SHEET NO.
EX-1

CONCEPT SITE PLAN

OPPIDAN
COFFEE

BLOOMINGTON, MN

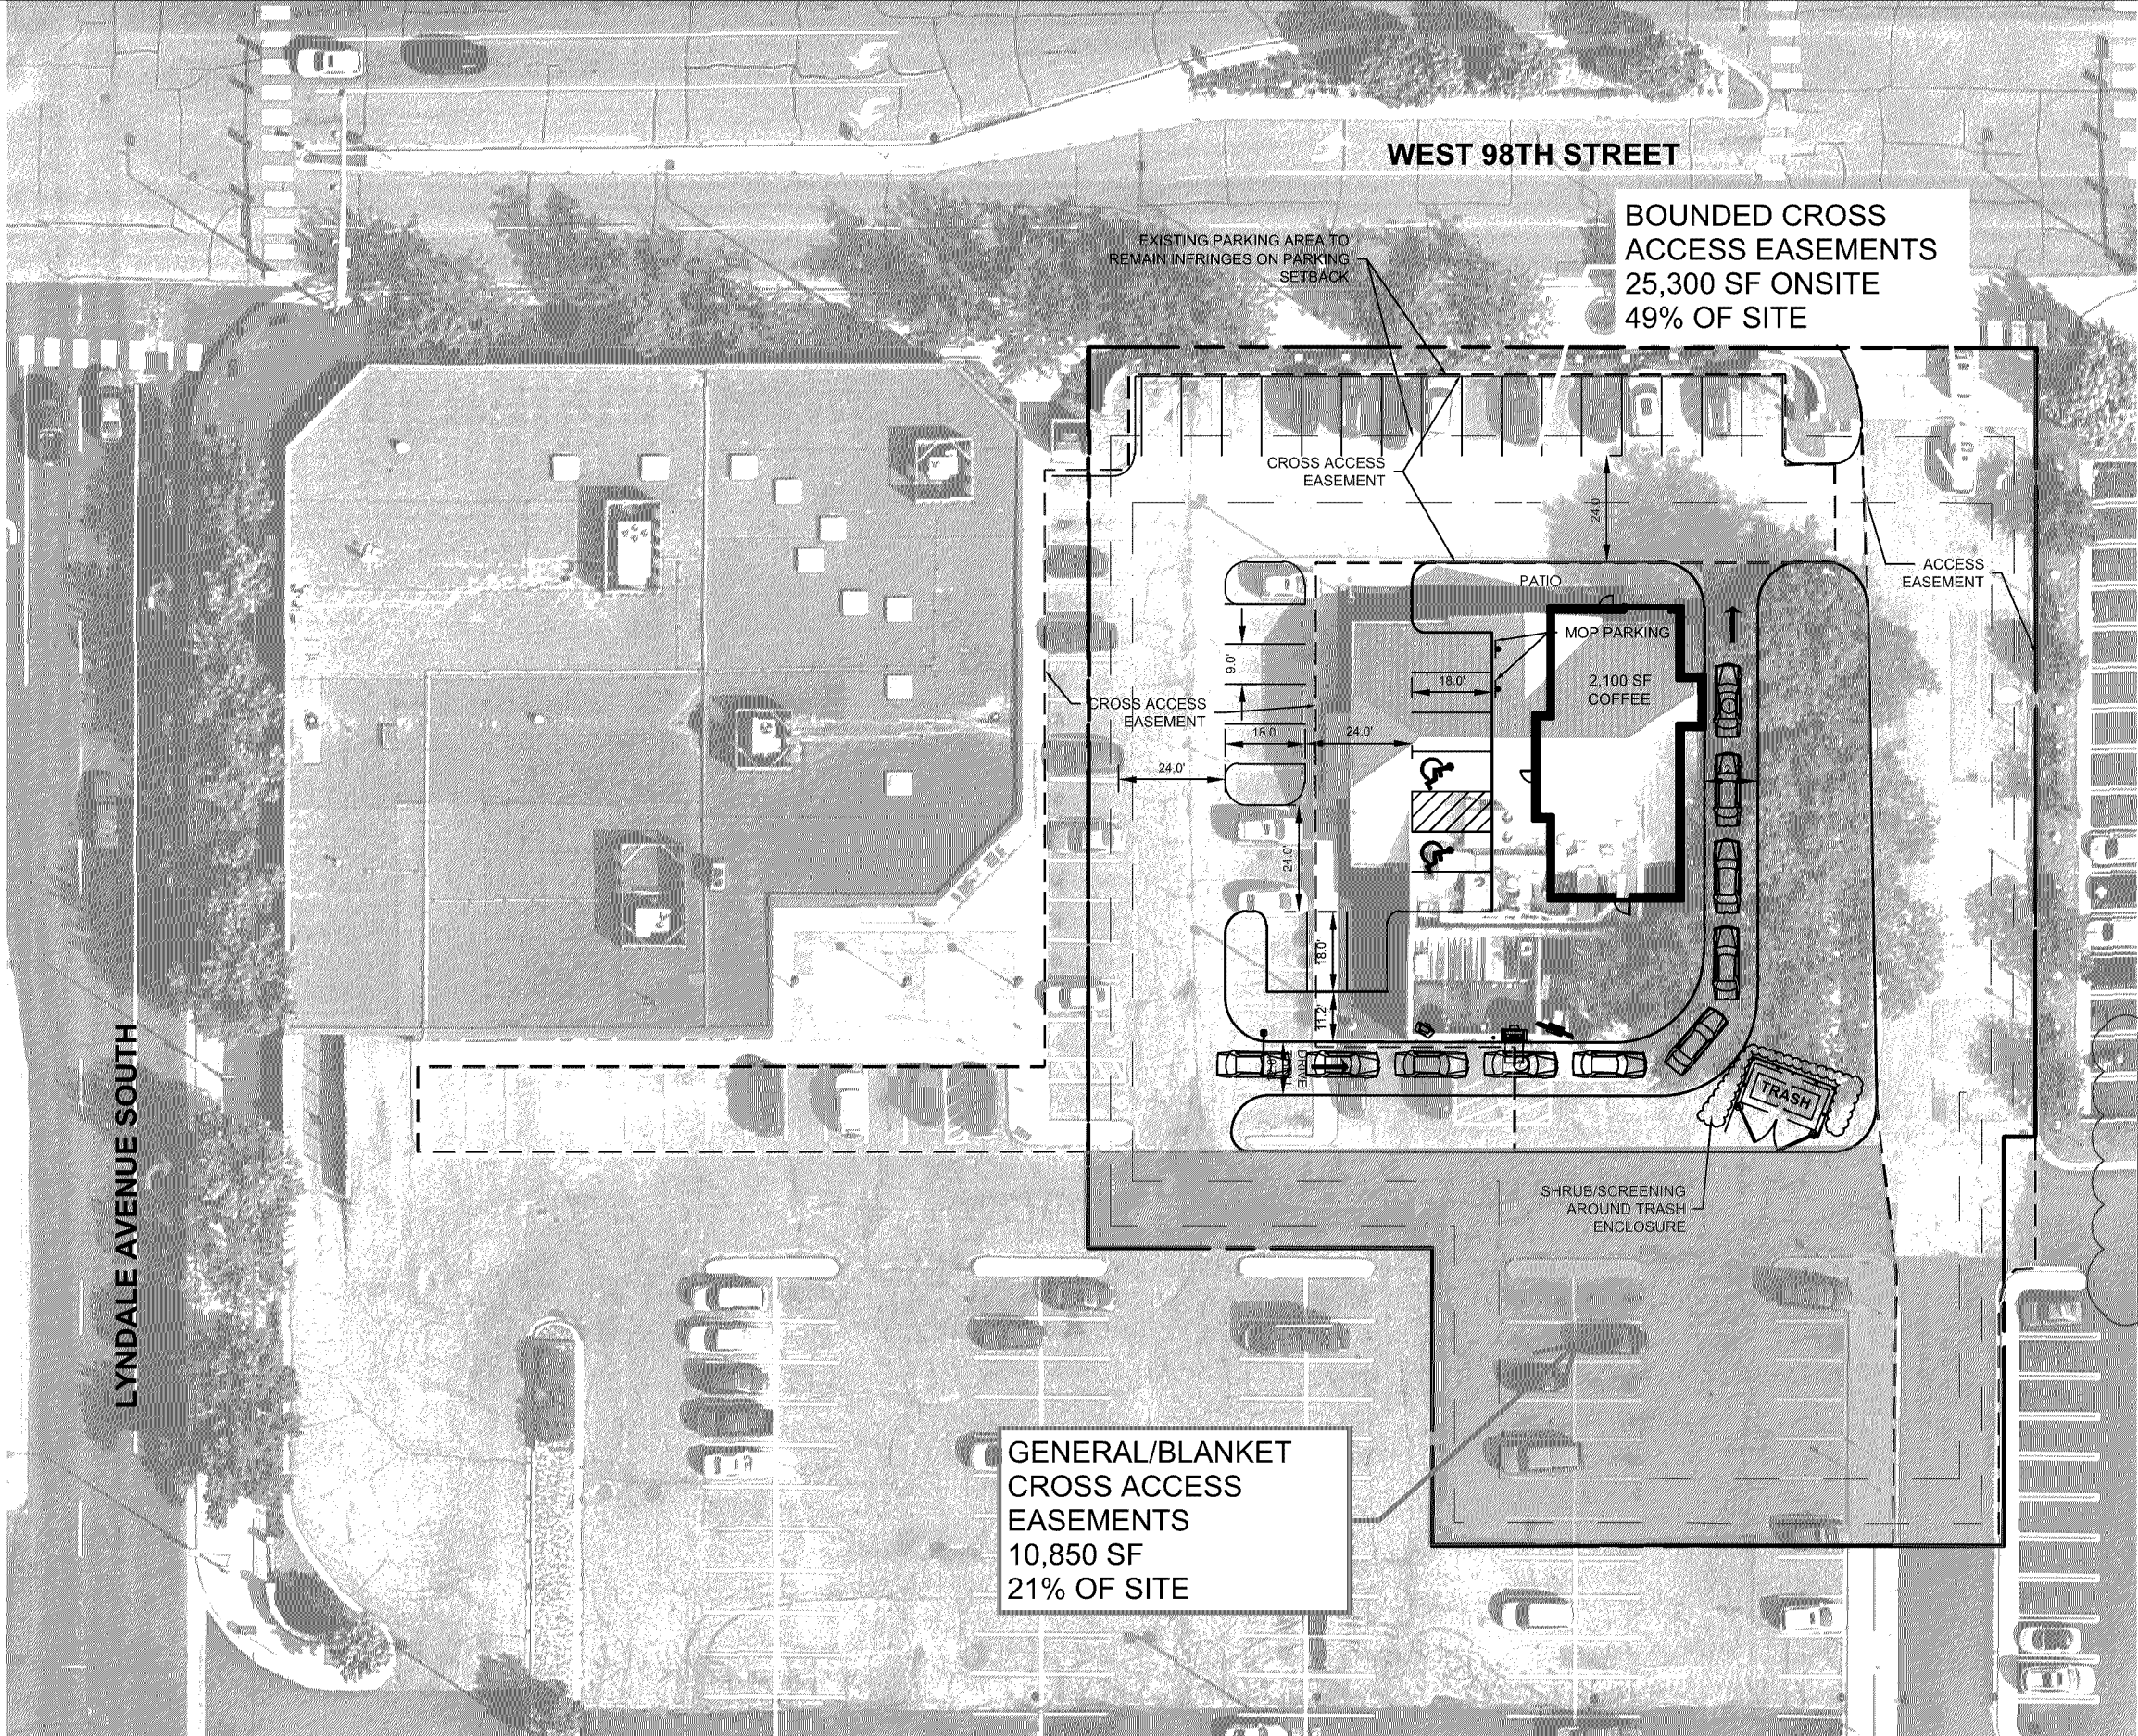
Trash and recycling storage must comply with Section 21.301.17 of the City Code. External trash storage is not permitted. The finish plan of the internal trash room must meet the performance standards for food service facilities.

Show sidewalk realignment and connection in this modified area.

North access is too close to traffic signal and driveway traffic queue. Right-in only at this north driveway is recommended as it would function more safely and without backing up the drive through. Traffic exiting the site would go around to southern drive aisle.

Show the sidewalk through the site which should remain and/or be enhanced

Drive-through must have six stacking spaces from the first point of contact, which is the order board in this case. Stacking spaces must be a minimum of ten feet by 20 feet in size. See Section 21.301.05 of the City Code for drive-through standards.

Label modified drive/access aisle width

Minimum 7' sidewalk width adjacent to parking stalls

Building is required to be sprinklered per MSBC 1306.

Emergency responder radio coverage meeting the requirements of appendix L in the 2015 MSFC shall be provided throughout the property and within the structures.

Appliances/cooking producing grease laden vapors requires a hood and suppression system.

Hydrant coverage shall be provided within 50' of the FDC and within 150' of all portions of the structure.

Provide for the new structure and maintain for existing structures emergency vehicle access throughout the property.

Must meet current MN State Building Code

Must meet MN Accessibility Code

SAC review by MET council will be required.
